Southern California Edison
A.09-09-022 – ASP

DATA REQUEST SET CPUC - Supplemental Data Request - 018

2023 Habitat Assessment for the Alberhill System Project

Figure 1: Survey Area Map

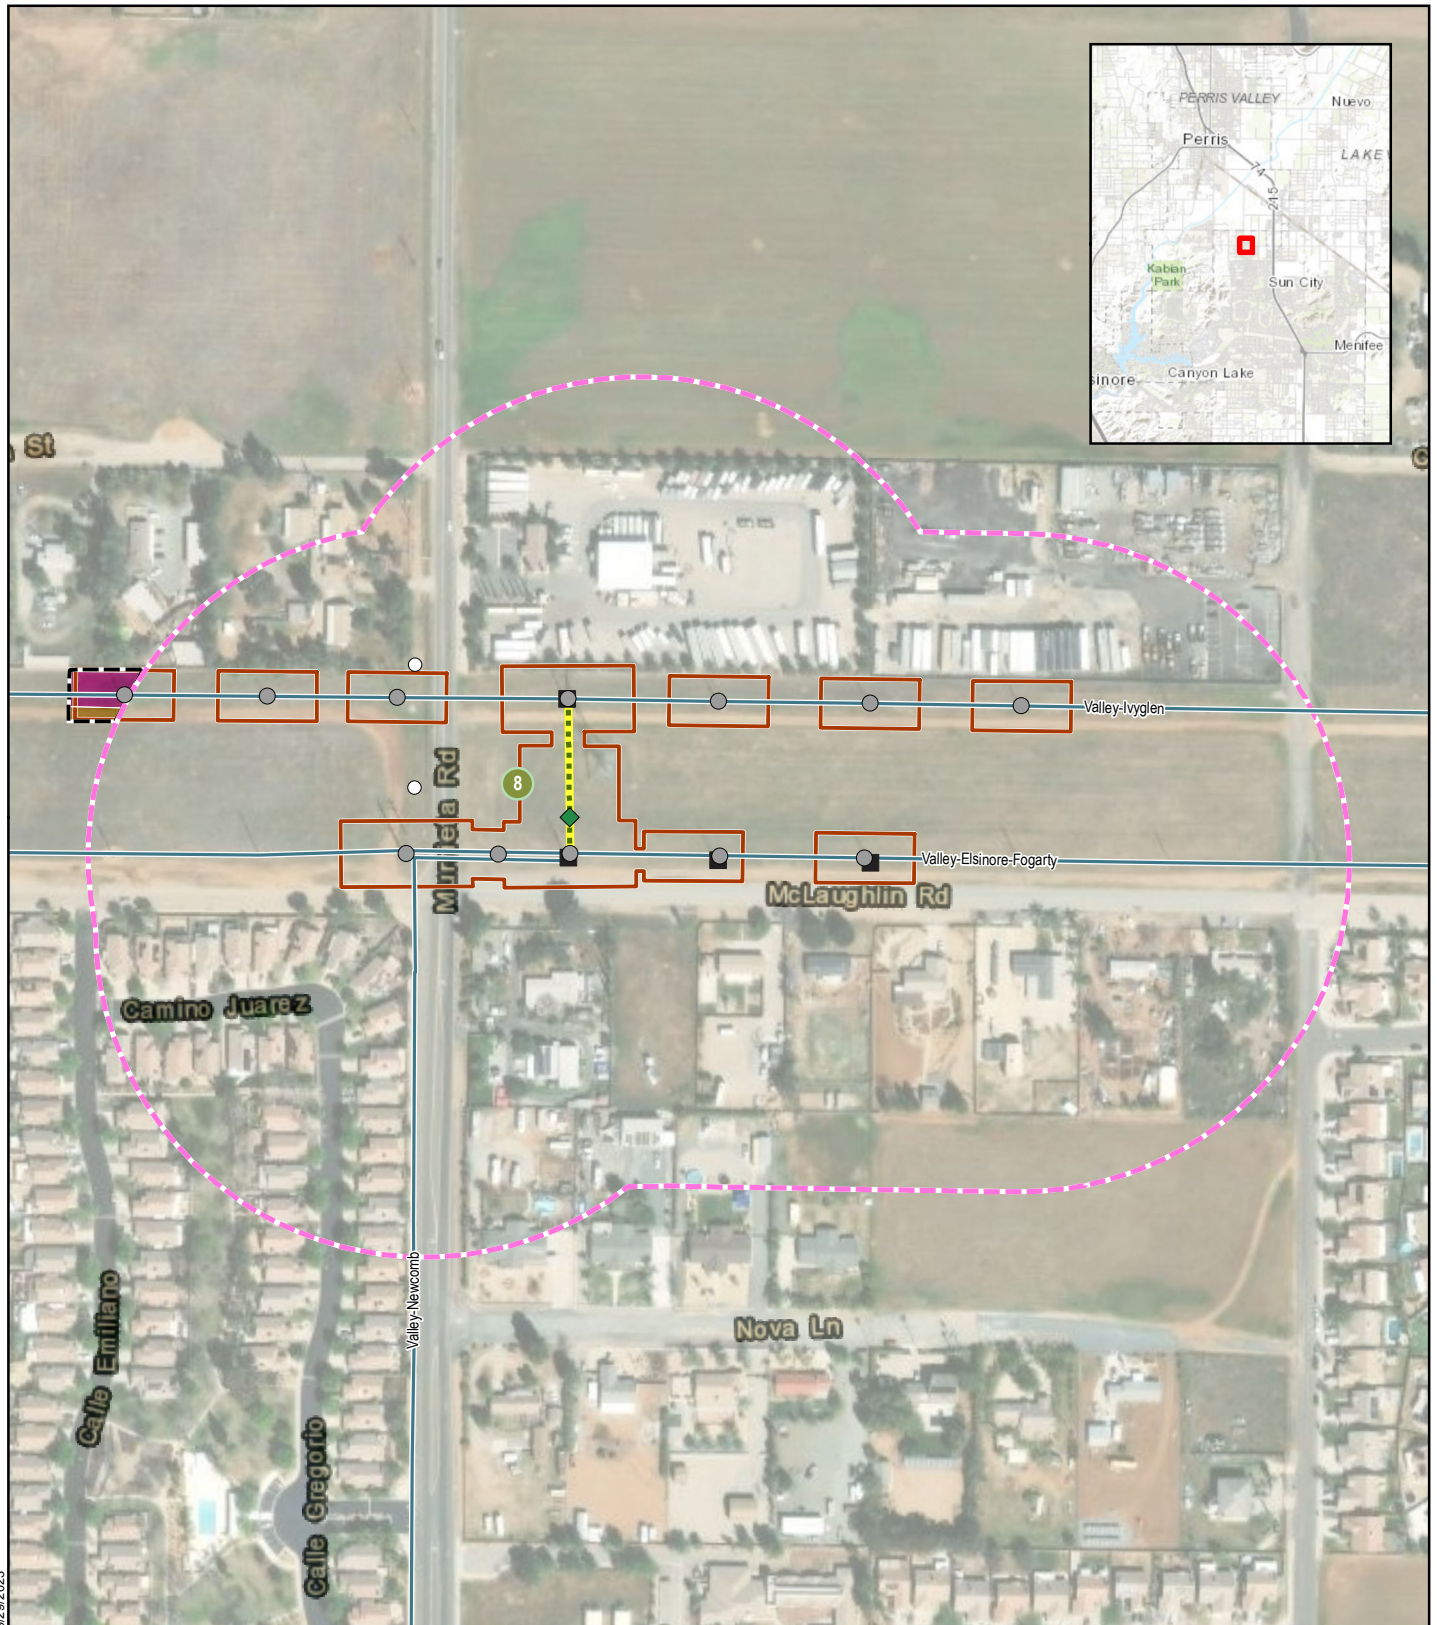
On September 21, 2023, Brian Cropper (Biologist, Insignia) conducted a habitat assessment for SCE's Alberhill System Project (Proposed Project) within a work area associated with Segment ASP8 of the proposed 115 kilovolt (kV) subtransmission line in western Riverside County, California. The survey area for this habitat assessment was limited to an approximately 0.2-acre site that was not surveyed during previous vegetation community surveys. The survey area is depicted in Figure 1: Survey Area Map. This memorandum describes the methods and results of the survey.

The survey area is located within an existing SCE transmission line corridor northwest of the city of Menifee. A majority of the disturbance areas associated with the Proposed Project in this location were surveyed as part of previous habitat assessment efforts. As depicted in Figure 1: Survey Area Map, the western portion of one planned temporary work area is located outside of the areas that were previously surveyed. This temporary work area is located in a flat valley with minimal topographical diversity. The temporary work area is primarily surrounded by residential development and is located in a rural area with limited native vegetation communities.

During the 2023 habitat assessment, the survey area was observed to be devoid of native vegetation communities; it consists of disturbed habitat comprised of red stem filaree (*Erodium cicutarium*), dove weed (*Croton setiger*), vinegar weed (*Trichostema lanceolatum*), and non-native grasses. Non-native grasses were not identifiable due to recent trimming/mowing. The survey area appears to be consistently maintained and trimmed as part of operation and maintenance activities associated with SCE's existing transmission lines. When compared to the vegetation community types from SCE's Draft MSHCP Biological Resources Technical Report, this portion of the survey area could be considered non-native grassland; however, it provides very limited and low-quality habitat for any potential special-status species in the vicinity due to non-native grasses being maintained at ground level. In addition, a dirt access

road (bare ground) was observed traversing the survey area. No special-status species or hydrological features were observed. Due to the low quality of the habitat, no special-status species are expected to occur within the survey area.

Figure 2-61
115-kV General Disturbance Area
Alberhill System Project

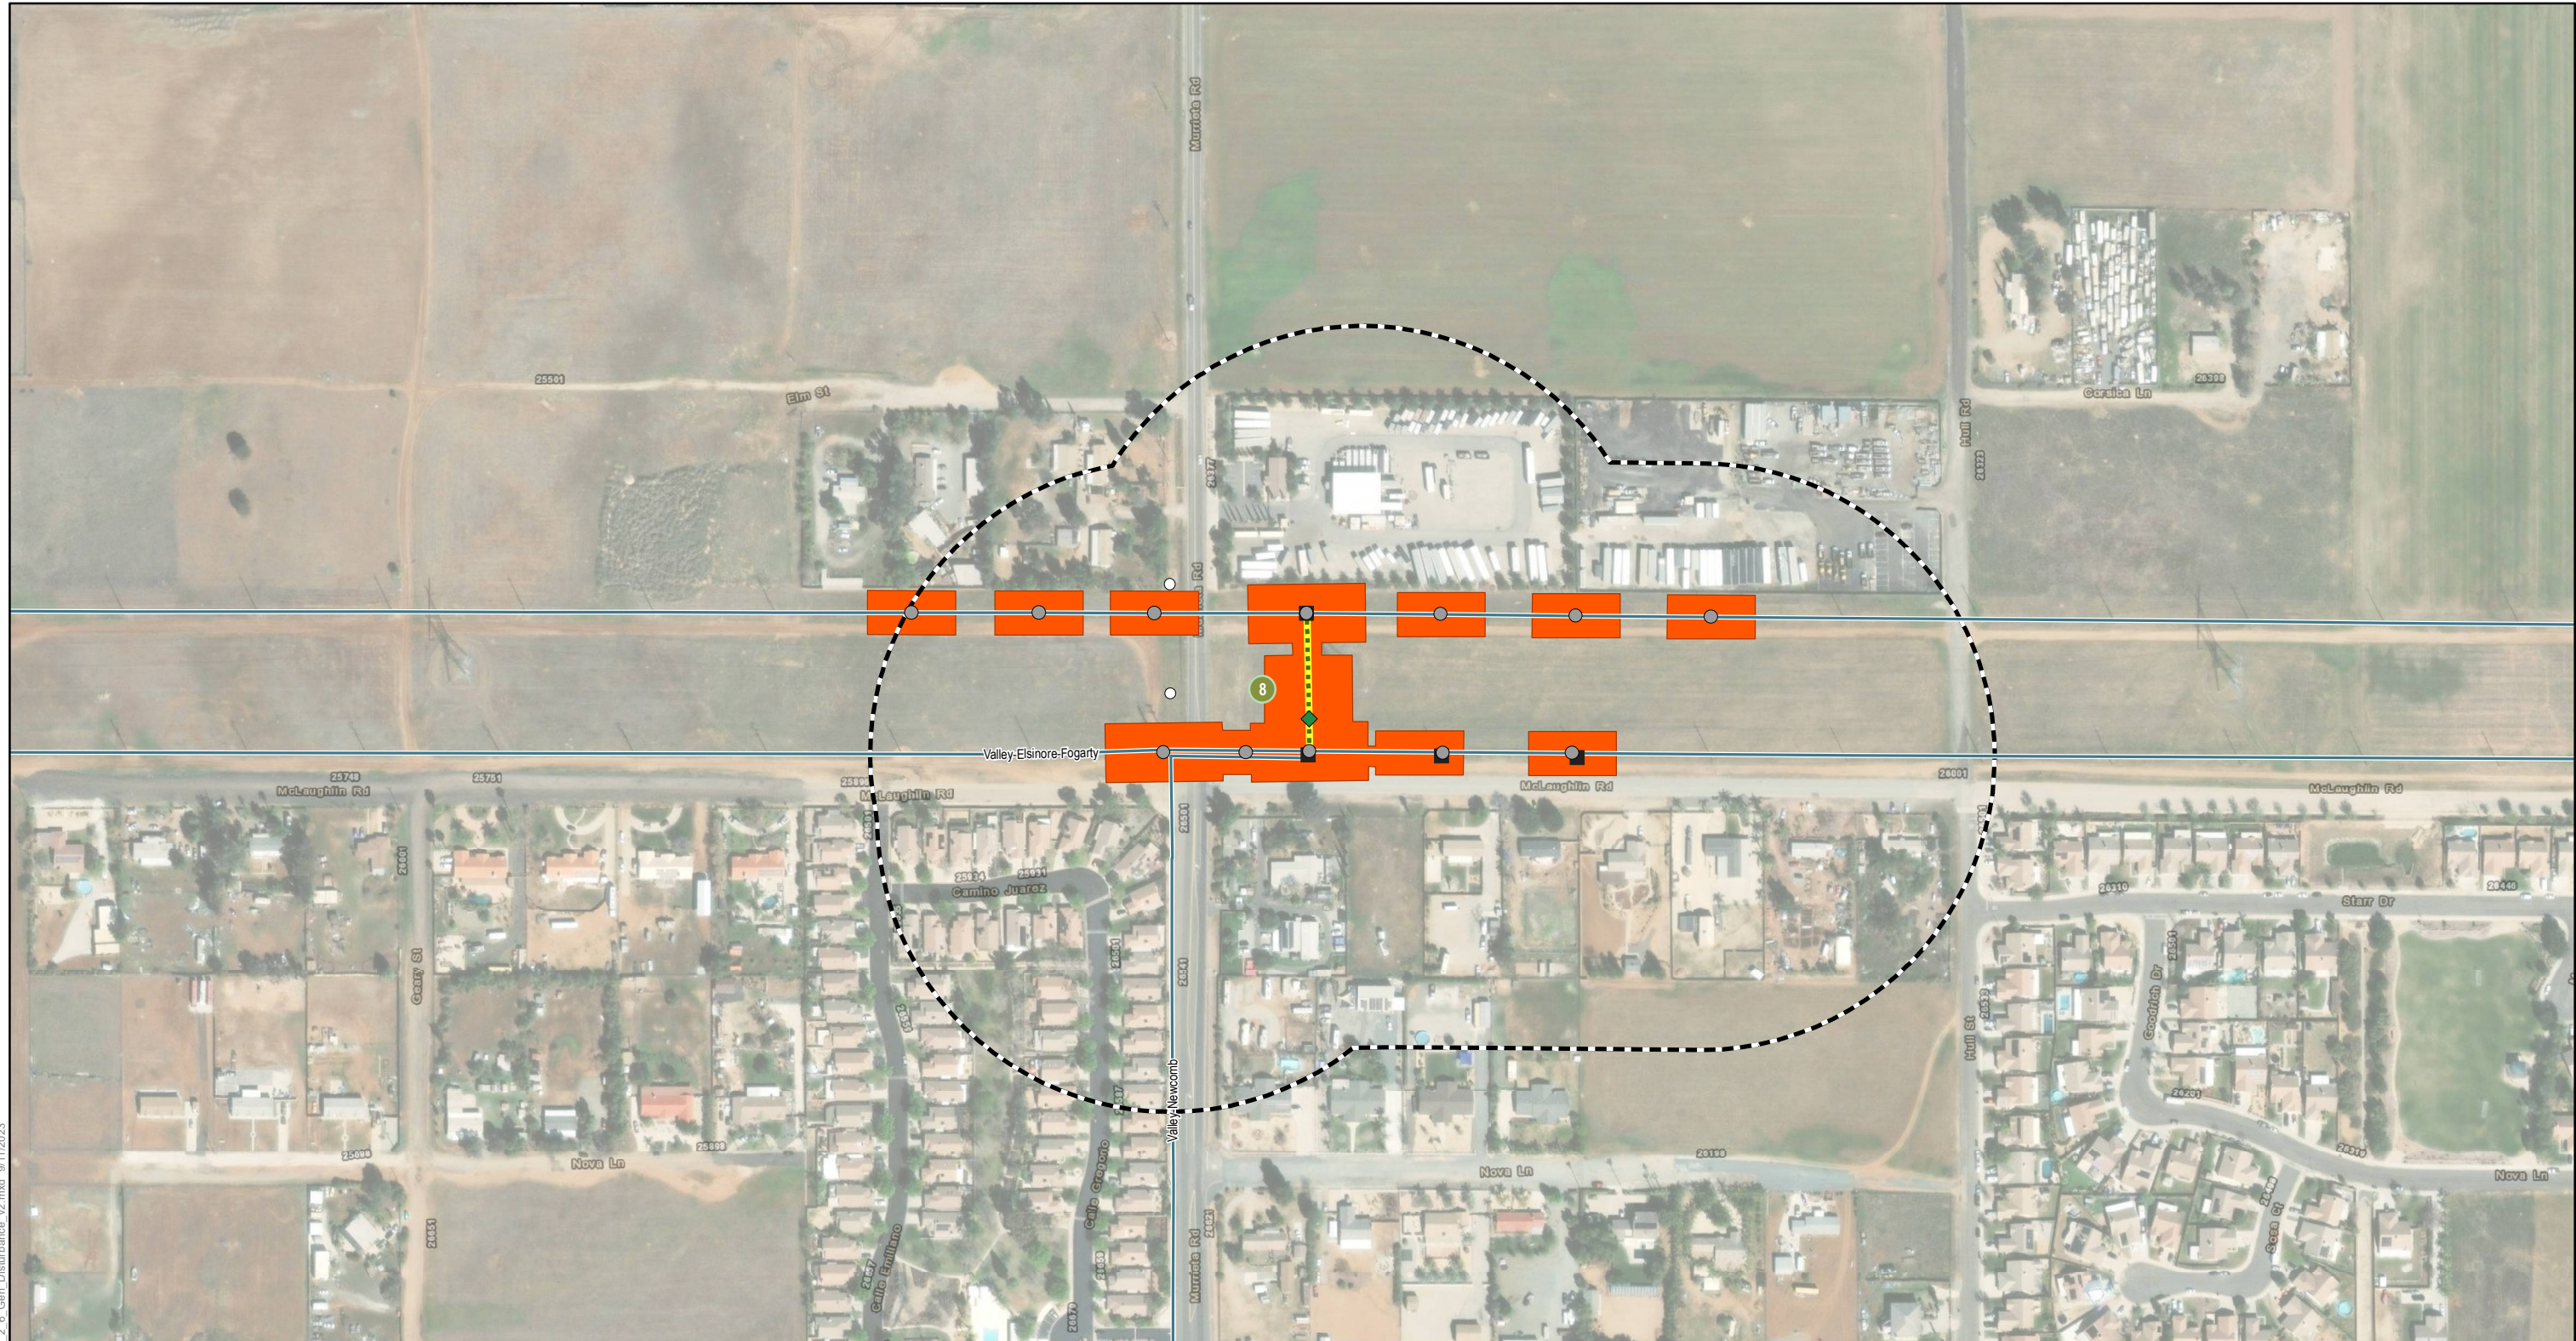
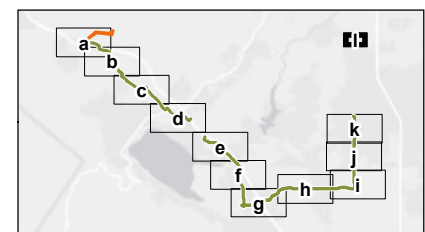
Provide the results for field biological surveys conducted within the 16.5 acres of additional temporary disturbance required outside of the previously identified general disturbance area. The results can be included in an updated Appendix F – MSHCP Biological Resources Technical Report for Alberhill System Project (i.e., Appendix F of the 2017 FEIR) or an updated Appendix E – Biological Surveys Conducted for the Proposed Valley Ivy-Glen and Alberhill Projects or Appendix G – Special Status Species Occurrence Potential for VIG and Alberhill, as applicable. Accordingly, update Tables 4.4-4, 4.4.-5, and 4.4.-6 in the PEA.

With the exception of a portion of one workspace along Segment ASP8 (See attached DG-MISC-88_Figure 2-61, 115 kV General Disturbance Area_ASP8 Survey Area Gap), the remainder of the 16.5 acres of additional temporary construction areas was analyzed during previous surveys, as described within Appendix A: Detailed Maps of the Study Area of the Draft MSHCP Biological Resources Technical Report.

A supplemental habitat assessment will be performed along the above specified ASP8 workspace portion to confirm that the existing vegetation type and special-status species potential which occur within said portion are consistent with the previously completed assessments for the remainder of the 16.5 acres of additional temporary construction areas. Once the supplemental habitat assessment is complete, SCE will provide any necessary updates to Tables 4.4-4, 4.4-5, and 4.4-6 from Appendix O: Revised Environmental Impact Analysis.
